New Jersey Department of Environmental Protection Site Remediation Program

Document: "Response to NJDEP Comments on Parcel 49- Revised LWPA"

SUBJECT: Revised Letter Work Plan Addendum for Parcel 49, Former Squier Laboratory and other facilities, Fort Monmouth, New Jersey

Figure 1.7
Parcel 49 Layout and Sampling Locations

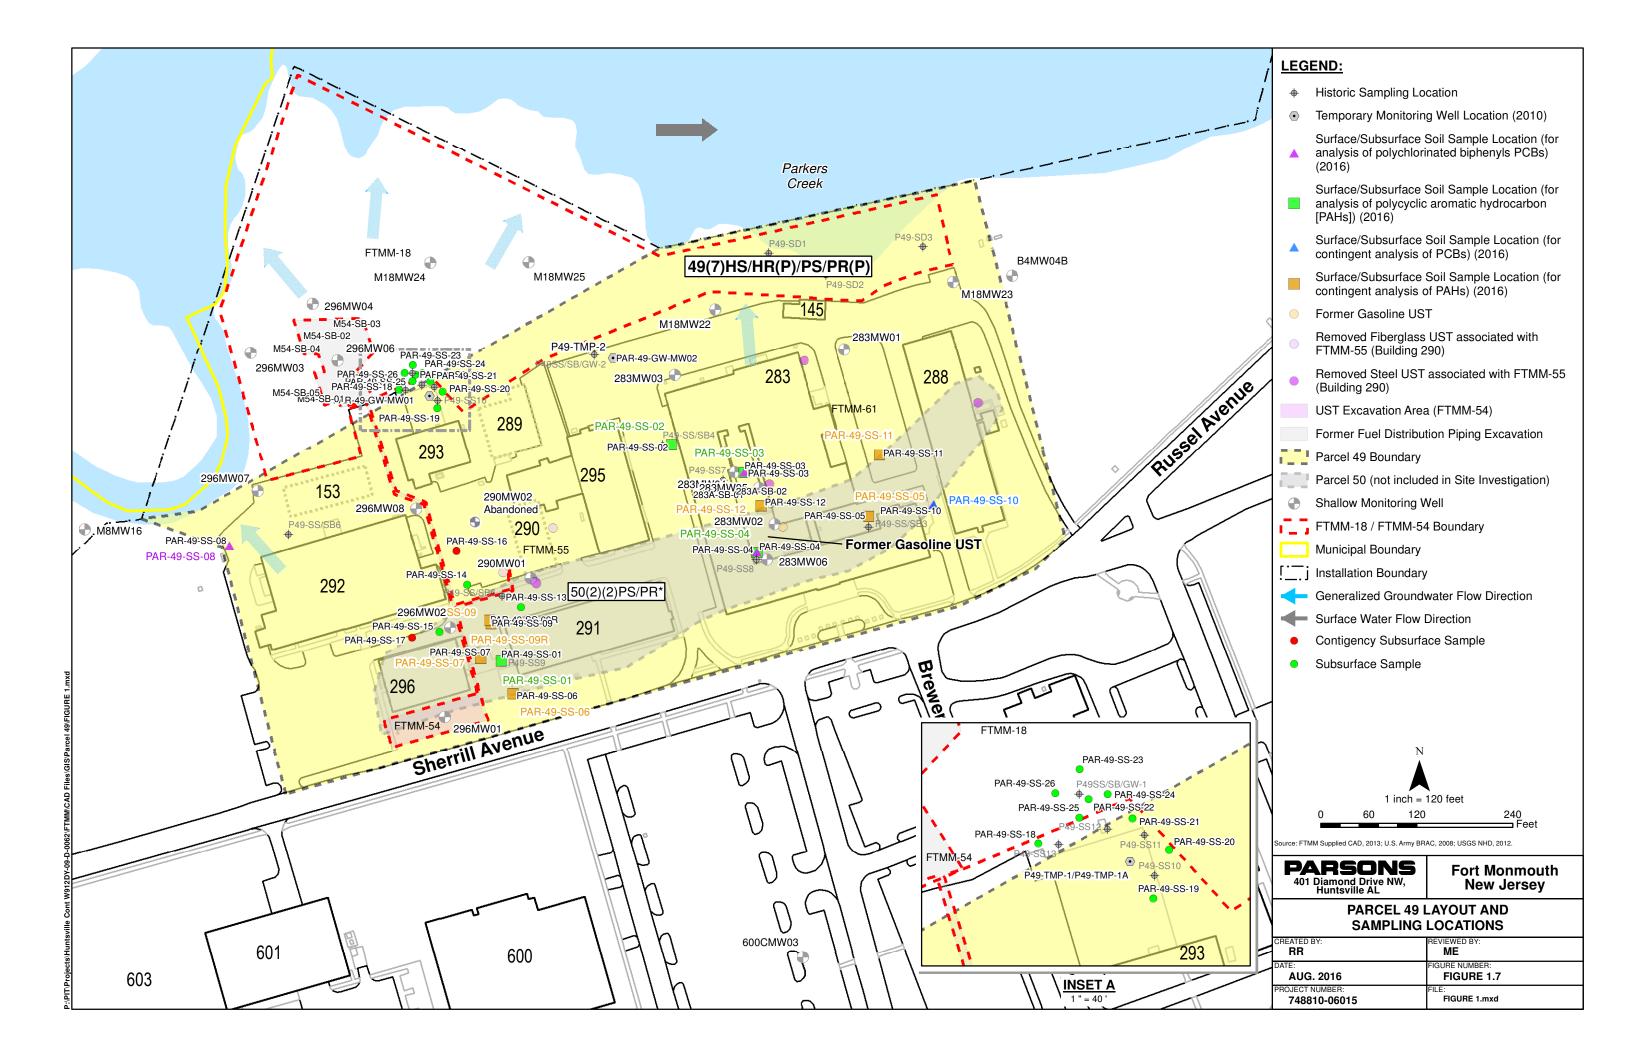
Work performed under the Rev.1 Environmental Condition of Property (ECP) Work Plan (WP) and approved by NJDEP in a December 2015 letter included the collection and analysis of soil samples from ten soil borings for PAH analysis, and six soil borings for PCB analysis, as shown on **Figure 1.7**. Soil samples were collected as described in the ECP-WP. Based on the results, detections of PAHs and PCBs have been delineated horizontally and vertically at the sampling locations, except for PAHs at PAR-49-SS-07 and PAR-49-SS-09. As agreed in the NJDEP July 29, 2016 letter, horizontal delineation of PAHs northwest of building 291 will consist of advancement of three primary borings (PAR-49-SS-13, PAR-49-SS-14 and PAR-49-SS-15) and two contingency borings (PAR-49-SS-16 and PAR-49-SS-17) as shown on **Figure 1.7** (Buildings on Parcel 49 present limitations for drilling, and locations may change as necessary based on actual field conditions). Up to three samples will be collected from each of these boring as described in **Table 1**. Primary samples will be run for PAHs, and contingency samples will be extracted, held, and run for PAHs pending results of the primary samples.

Additionally, the July 29, 2016 letter states that the NJDEP is not in agreement with the Army's position that PAH exceedances of the RDCSRS in surface soils at borings P49-SS10 through SS13 are the result of diffuse anthropogenic pollutants (DAP), and notes that nearby sample P49-SB1/SS1 exceeded the RDCSRS for PAHs in the 6 to 6.5 feet bgs interval. The Army maintains the position that the low concentrations of PAHs in the surface soils are the result of DAP and are not the result of a release, and therefore do not require investigation. Additionally, P49-SB1/SS1

is located adjacent to Landfill FTMM-18 and the low concentrations of PAHs at 6 to 6.4 feet may be the result of fill and or landfill in this area, and not attributable to a release at Parcel 49. However, FTMM will perform limited additional characterization to provide evidence that these exceedances are not attributable to a release, but instead are low level exceedances representative of DAP or anthropogenic background in this area. To delineate or provide further evidence of DAP at the surface PAH exceedances, the limited additional characterization will consist of drilling four soil borings (PAR-49-SS-18, SS-19, SS-20, and SS-21) as shown on Figure 1.7 will be advanced around the area of the exceedances and collection of soil samples. Samples will be collected at the surface (in the 6 inch interval below the asphalt and subbase) and in subsurface soil as described in **Table 1**. At the one location where PAHs were found at 6 to 6.5 feet, the limited investigation will consist of drilling one vertical delineation boring (PAR-49-SS-22) adjacent to existing boring P49-SB1/SS1 to vertically delineate the PAHs at 6 to 6.5 feet, and four additional step-out borings (PAR-49-SS-23, SS-24, SS-25, and SS-26) around the vertical boring location. At the vertical delineation boring, soil samples will be collected from 9 to 9.5 feet. At the four additional step-out borings, samples will be collected from 6 to 6.5 feet for horizontal delineation. These sample results will be used to determine if there is any evidence that these PAH exceedances could be attributed to a release (e.g., higher concentrations and a concentration gradient) at Building 293.
